**MONACO VILLA
EXTERIOR
REMEDiation**

01/24/24
DESIGN COMMISSION

UPDATED DESIGN
USING COMMENTS

ENLARGED AERIAL VIEW

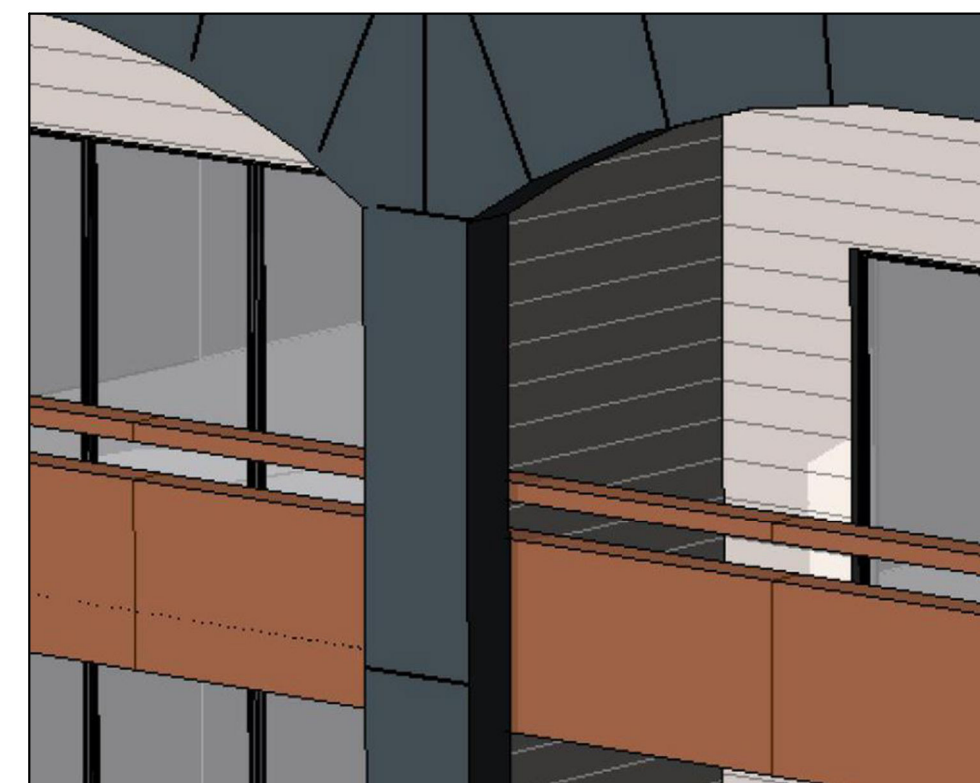
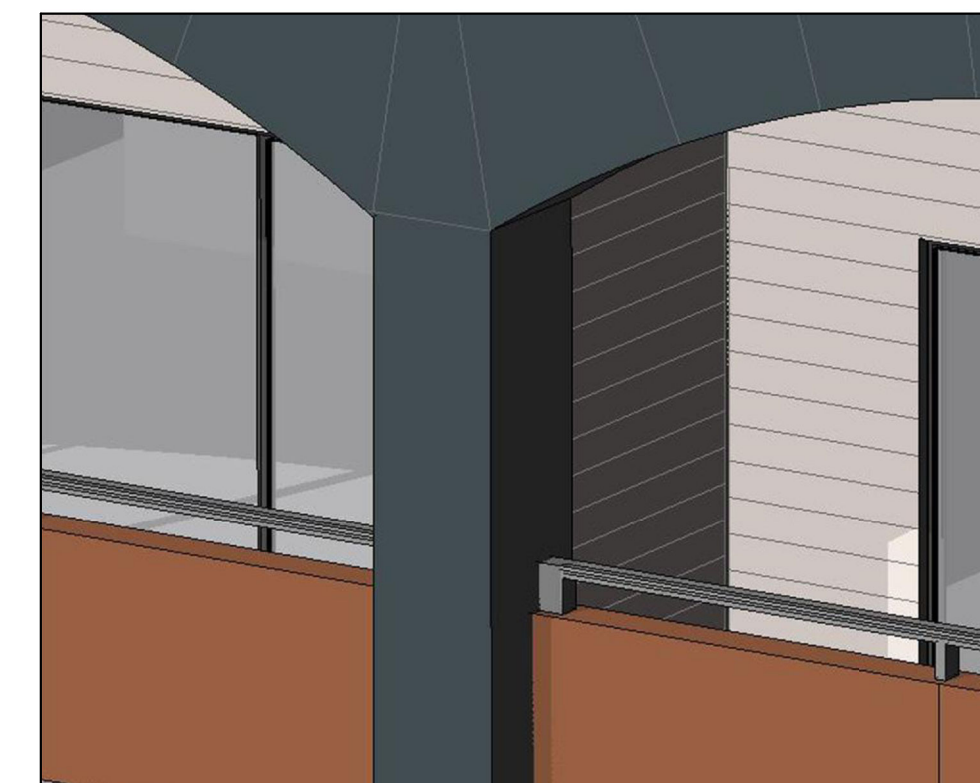
ORIGINAL ENTRY CANOPY WRAPPED IN TRESPA

ORIGINAL COLUMN TREATMENT APPEARED SOMEWHAT SHALLOW

ORIGINAL END FACADES TREATED IN A SUPER GRAPHIC

UPDATED COLUMN TREATMENT READS AS MUCH MORE SUBSTANTIAL

UPDATED ENTRY CANOPY WRAPPED IN COPPER REUSED FROM THE CURRENT BUILDING

UPDATED END FACADES MIRROR EAST FACADE RHYTHM AND SCALE
